# Administrative Design Review

## Recommendation Packet

111 / 115 21st Ave E

3019295

East Elevation  
nts

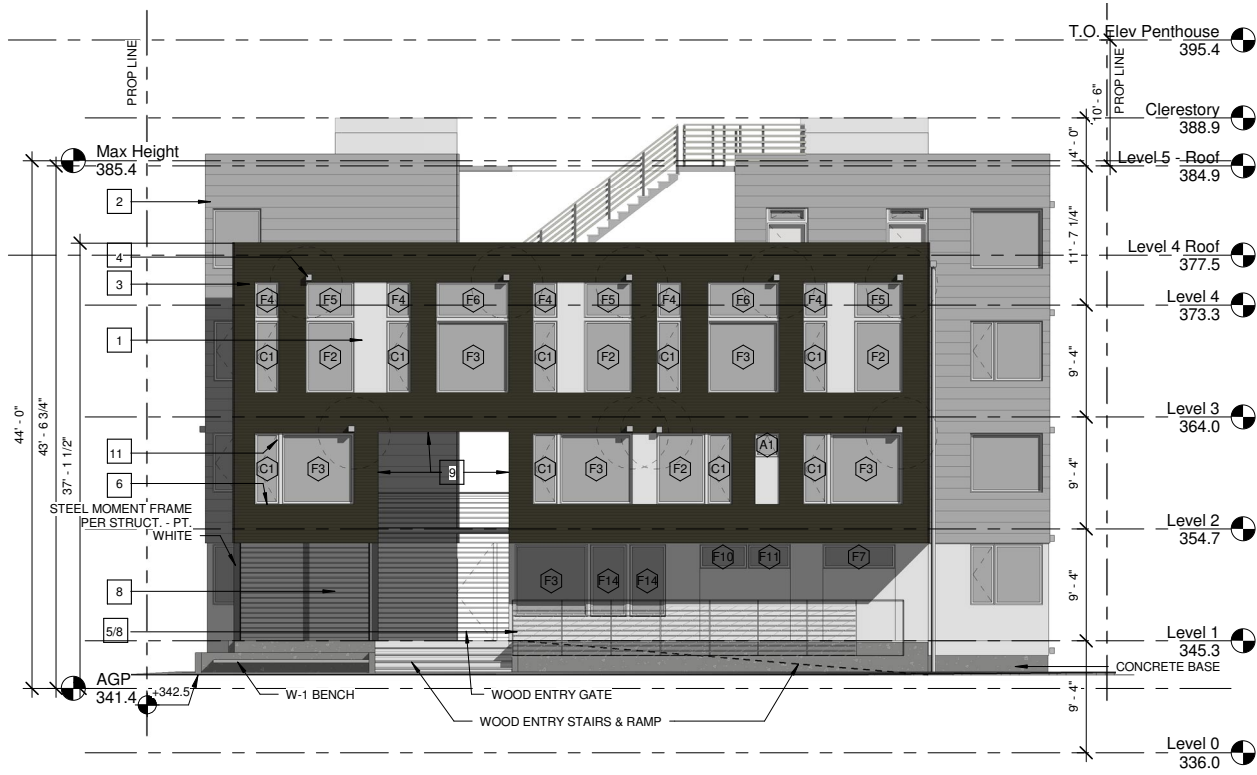
2. East Façade. Refine the east façade to create a cohesive design composition that is well proportioned and expresses a scale appropriate for the contextual character.

a. The lifted base expression reduces the presence and bulk of the structure along the streetscape. However, the top three floors of the building appear quite heavy and out of balance with the base. Consider strategies to further reduce the perceived bulk of the upper floors, and to integrate the base and top of the building into a cohesive composition. This may be achieved through color, material, or further modulation that unites the street-facing façade. (DC2-A, DC2-B, DC2-C, DC2-D).

c. As presented ...”notches” appear unrelated and random. Consider redistributing ... to open up the porch. Break in fenestration pattern appears to draw attention to height of building, which should be minimized instead.

d. As studied in the EDG packet, consider using secondary architectural elements, such as trim to further define the first story expression, highlight the porch and to relate to the neighborhood datum lines.

**DC2-A – 1 / DC2-C-2.** The mass of the building, along 21st, has been arranged “taking into consideration ... the proposed uses of the building and its open space”. The base of the building is to appear much more open, connecting the interior courtyard as well as the public space with the pedestrian environment. By conceptually lifting the building up and treating the building with a lighter material with generous glazing encourages that visual and conceptual openness of the ground floor.

**DC2-A-2 / DC2-B-1 / DC2-C-1** The mass of the top 2 floors has been reduced by removing an entire section of the elevation at the second floor to create a generous double height entry. To further reduce the perceived bulk of the project, an entire floor was removed from the street facing section of the project to step down the height of that volume to more closely relate to the neighboring properties along 21st.

**The height of the building, facing 21st Ave e, has been reduced by 1 story to lessen its impact on the street and to more closely align with adjacent properties. The double height notch at the south end provides a generous main entry to the project, while the smaller notch at the north end of the eastern façade creates a balanced yet playful façade.**

**The building will feature recessed windows that will have trim lining the interior of that recess which will be painted in a complementary but contrasting color to the façade to further set those openings apart and to provide a more human scale to the façade that responds to the more traditional trim of the neighboring buildings.**

North Elevation  
nts

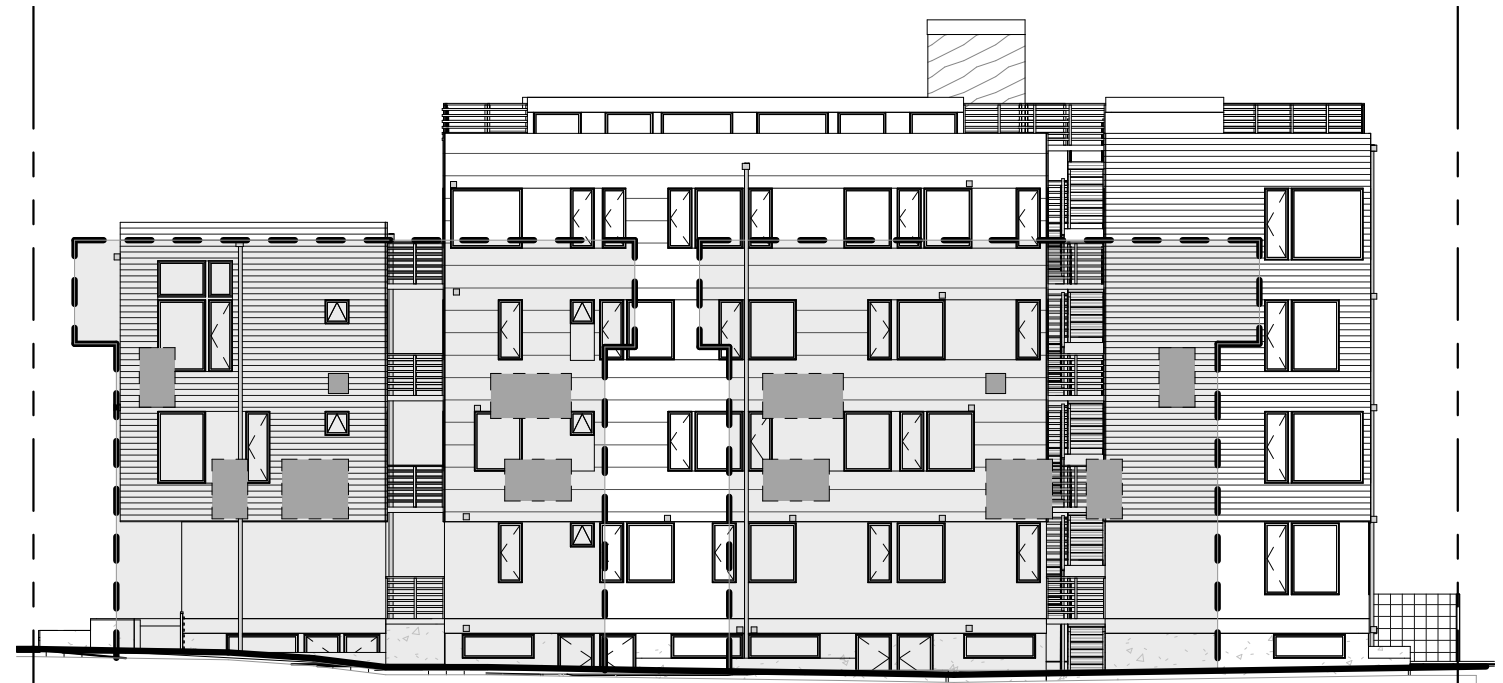
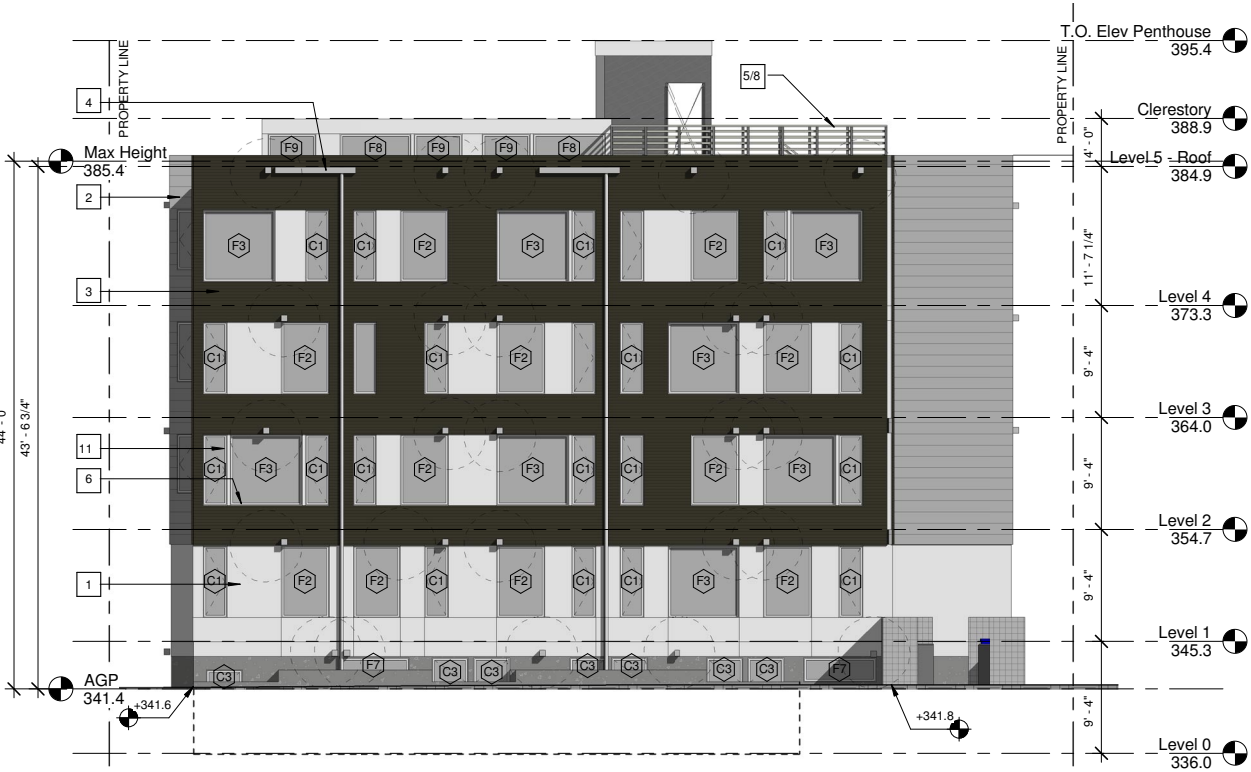
b. The design of the north and south facades should take the window placement of adjacent structures into consideration to preserve privacy impacts. Provide elevations that show a window study of the adjacent structures.

A privacy study has been conducted in relation to the adjacent properties at the north and south of the site and new openings have been placed with respect for privacy but to still allow adequate light, air and egress.

North Privacy Study:  
Window Openings have been placed to minimize direct  
sight between properties and to maximize privacy  
while also provide adequate access to light and air.

Exterior Lighting Plan

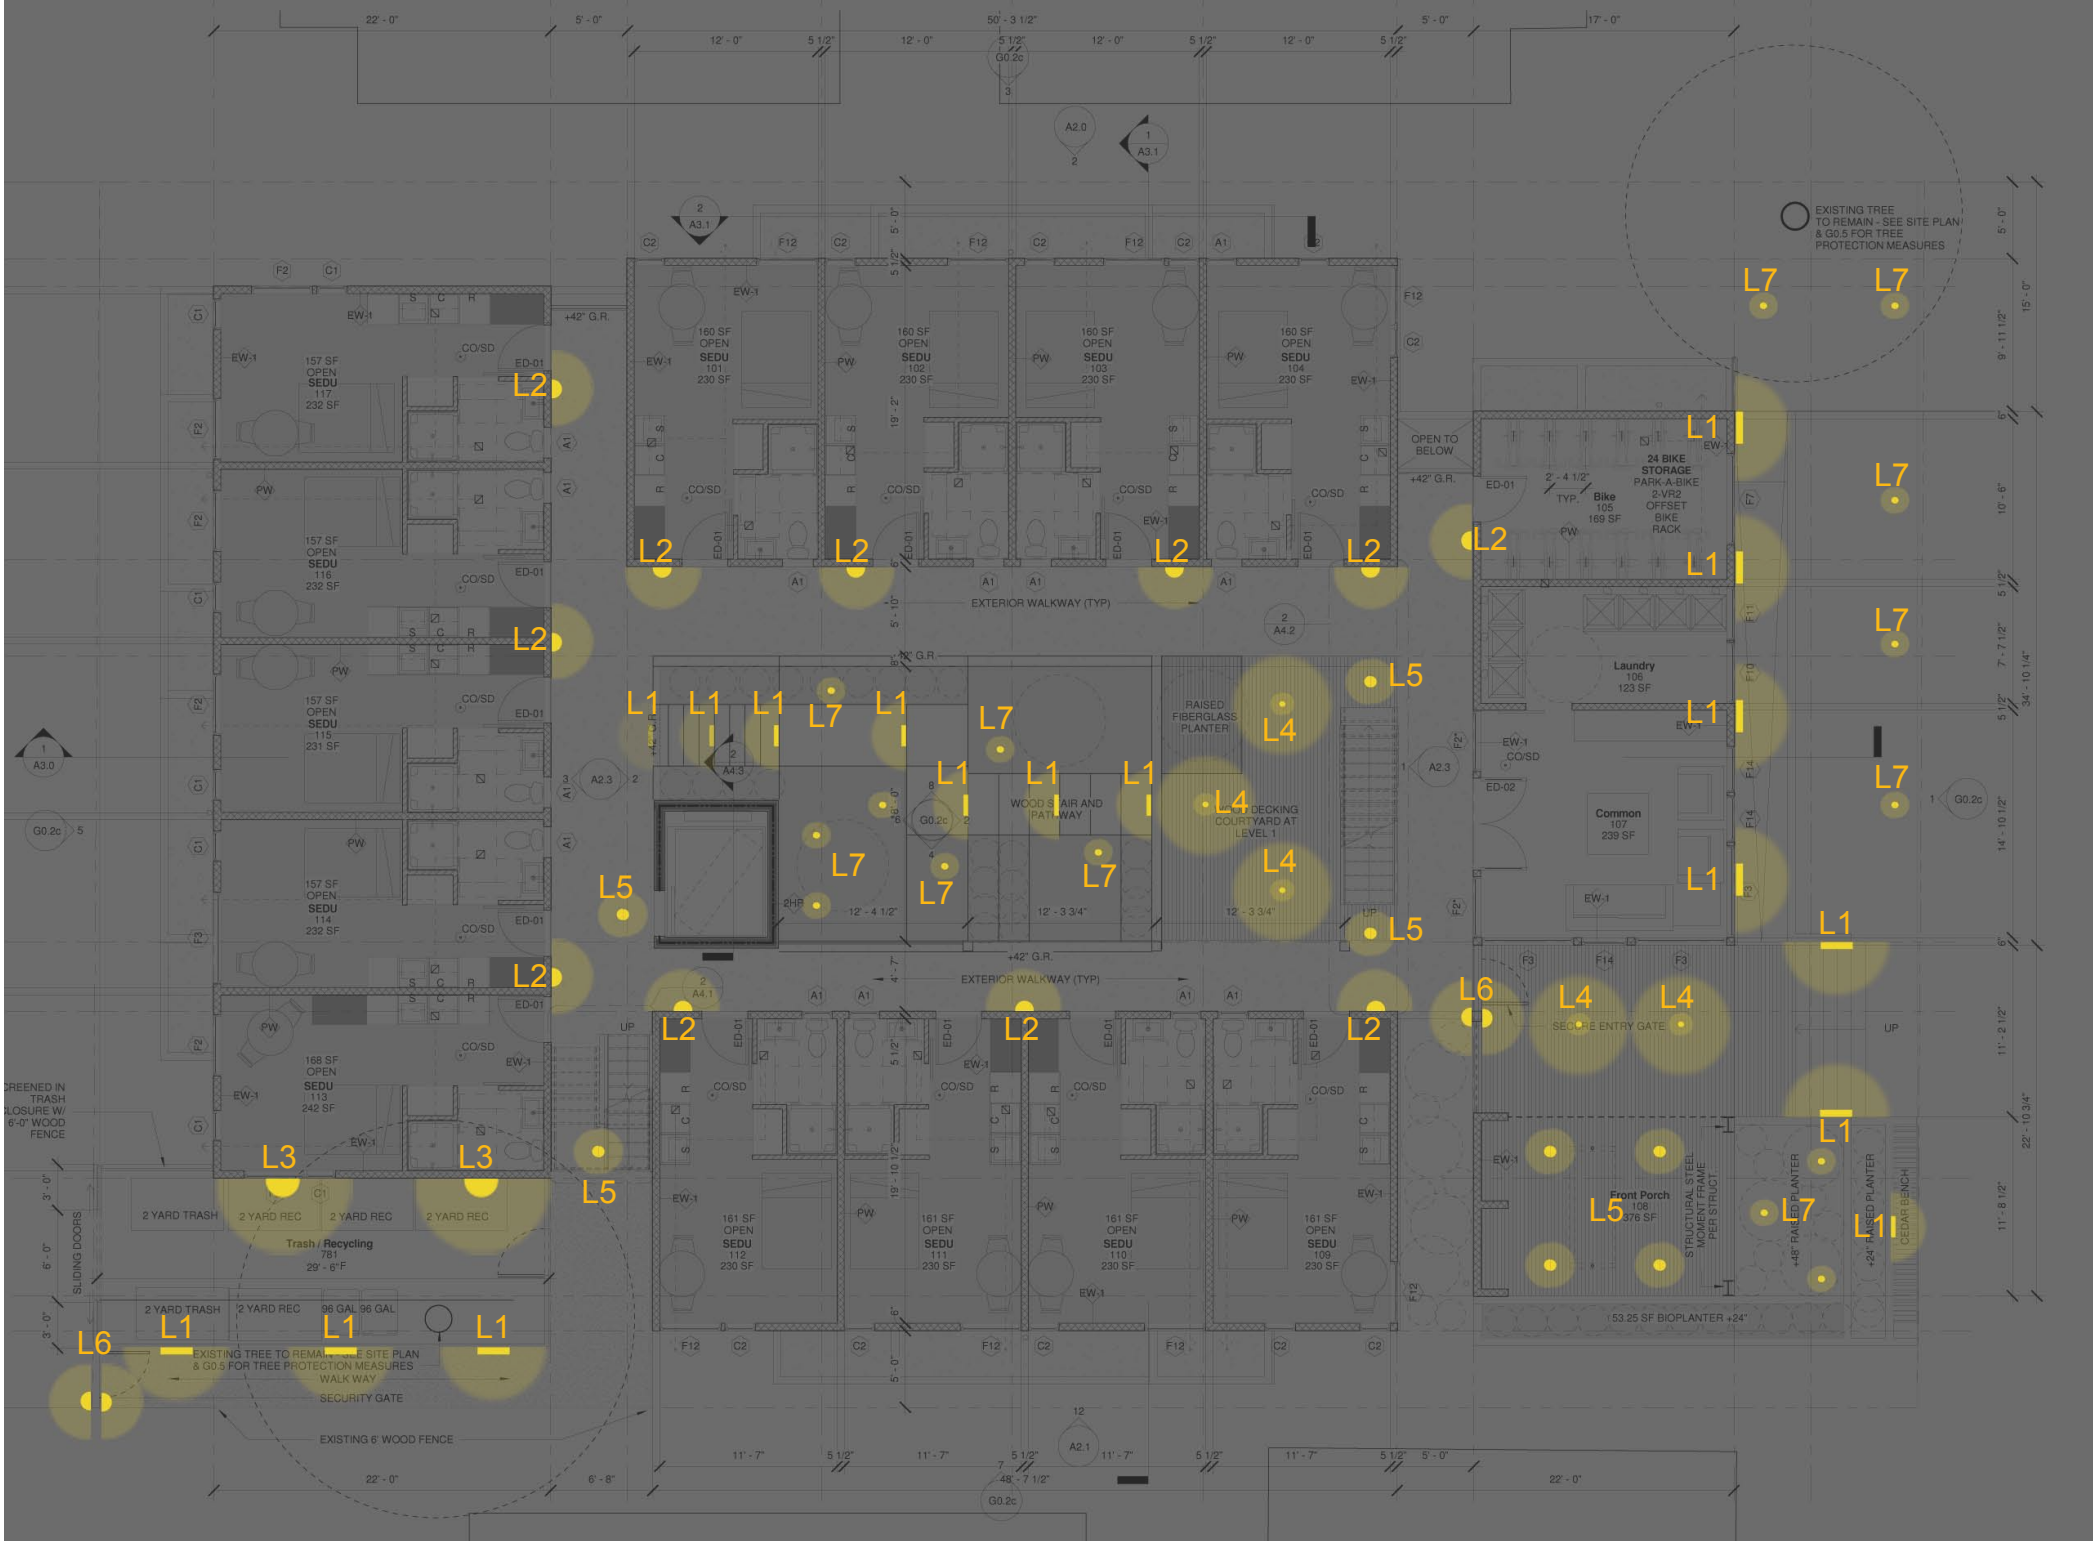
f. Provide lighting scheme for courtyard and/or covered porch

See exterior lighting plan

Rendered Landscape Plan

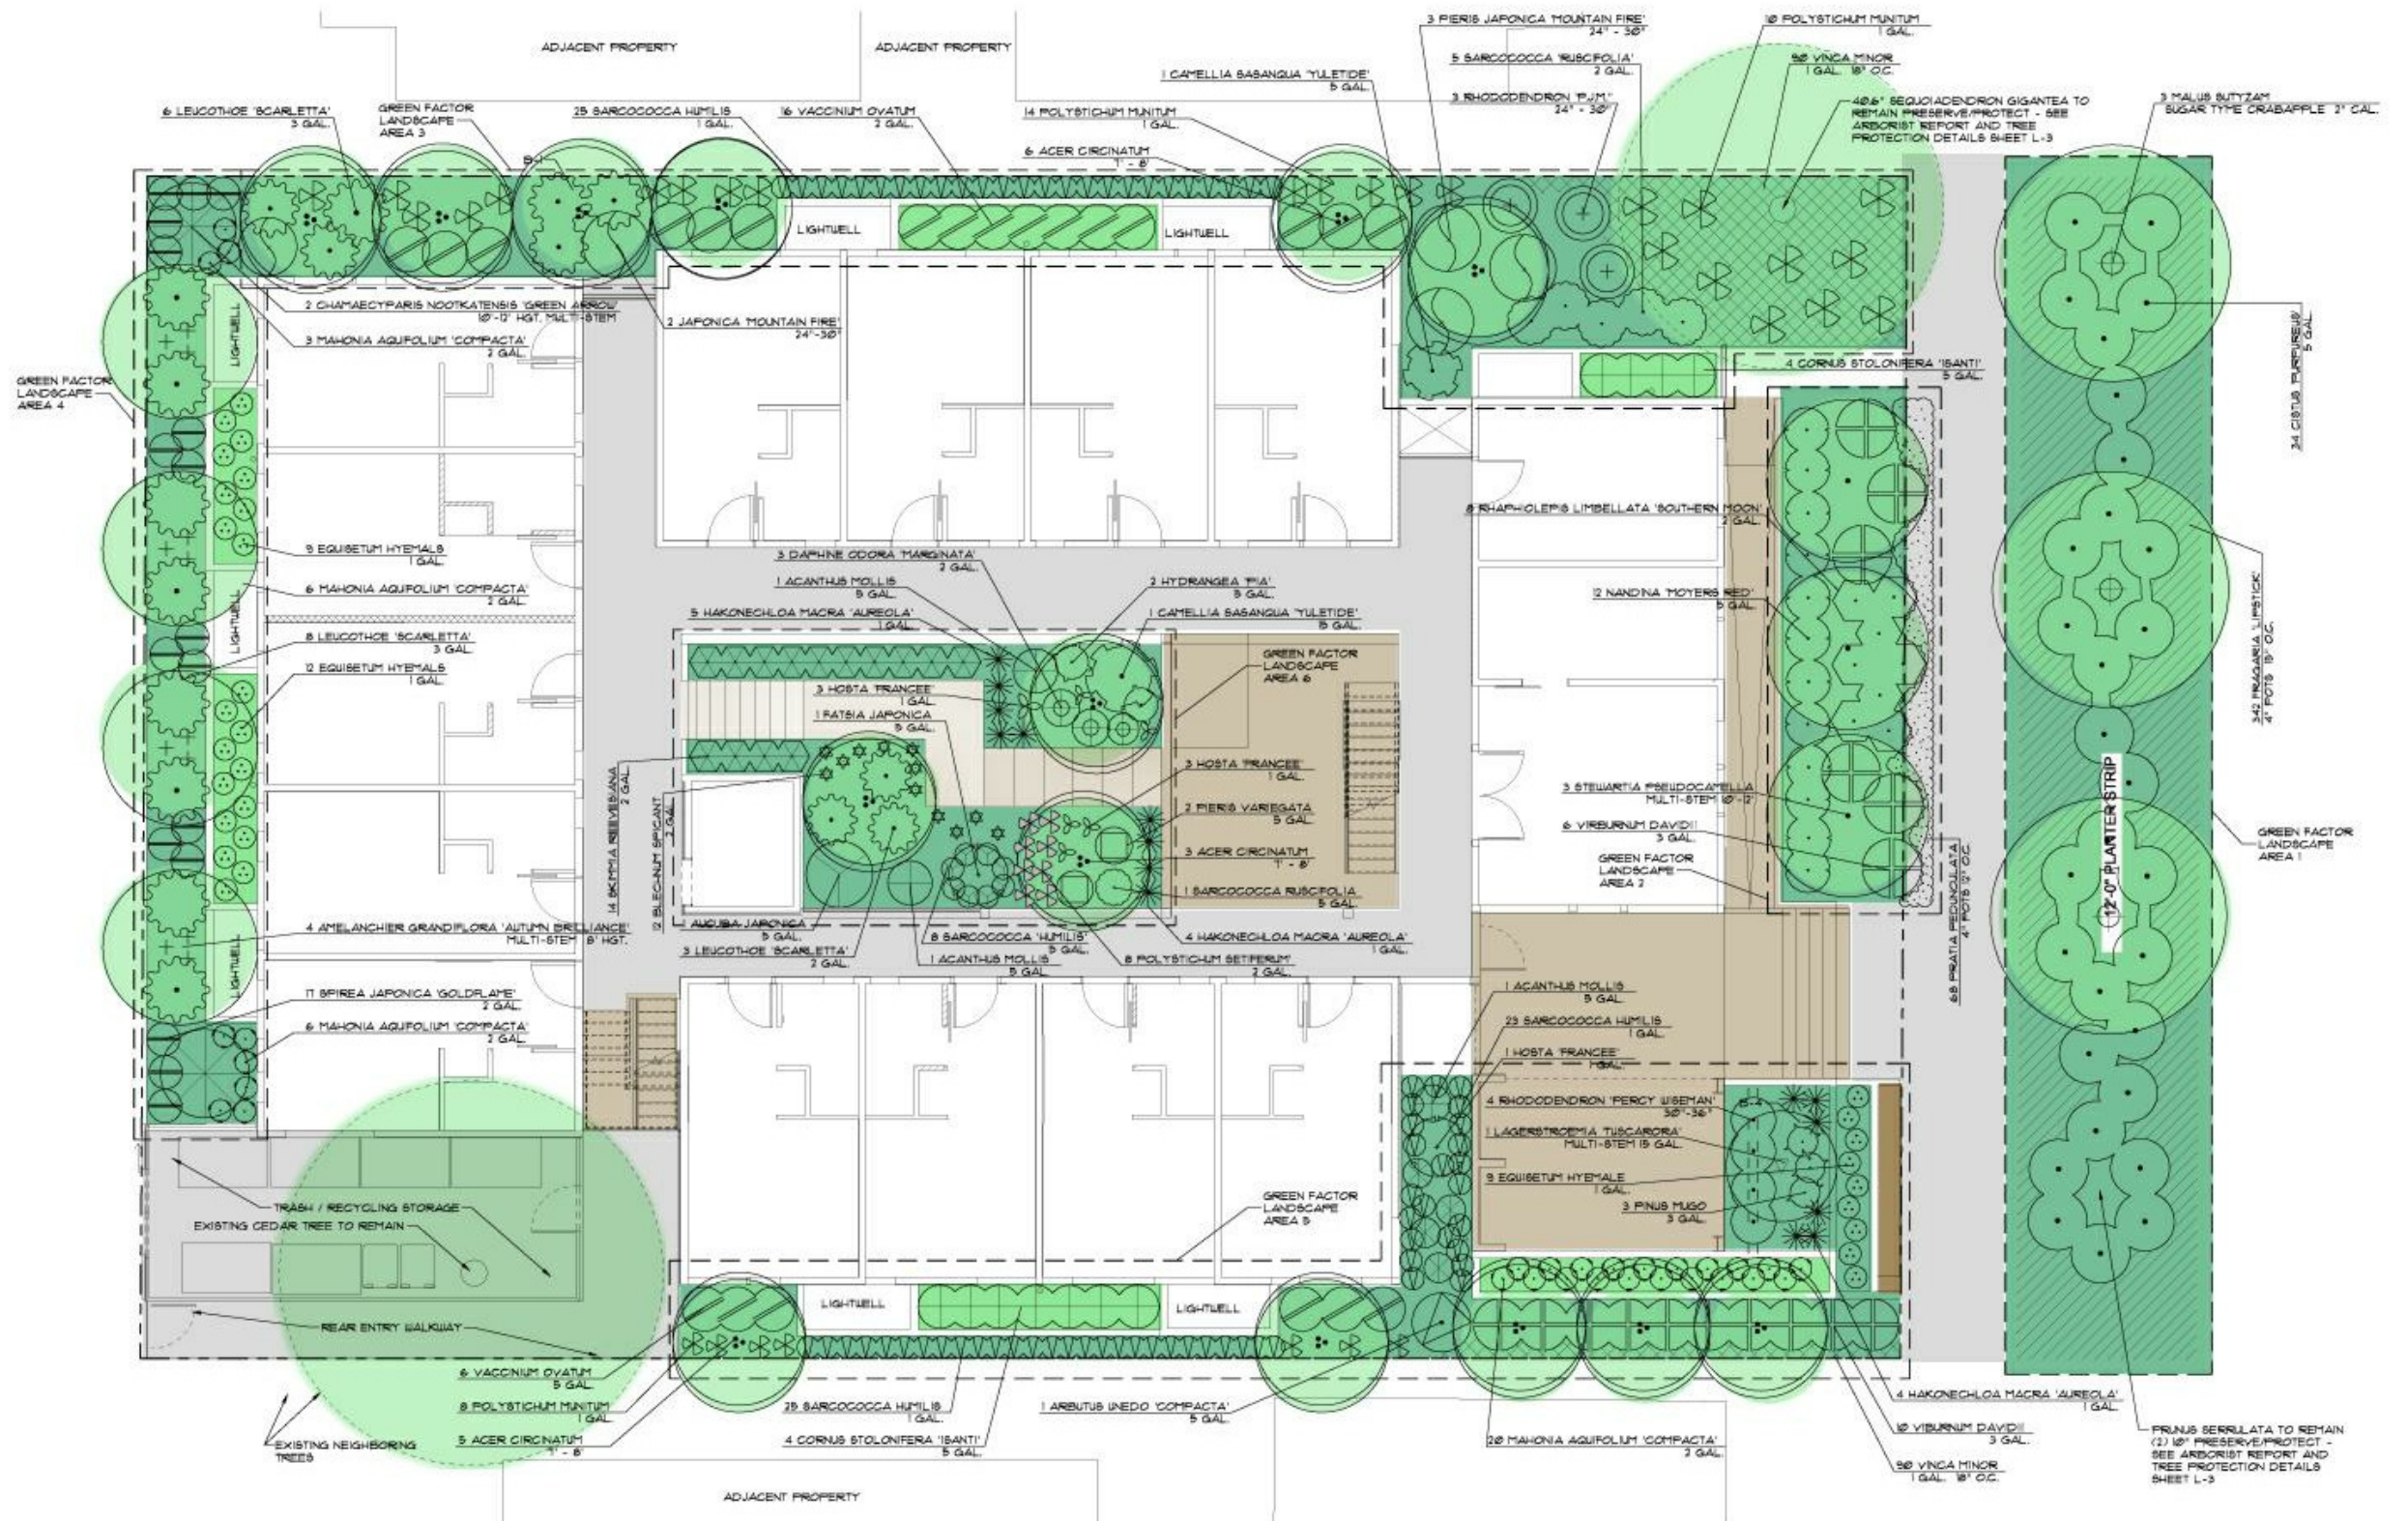
e. Provide more info regarding landscaping and screening

See landscape plans
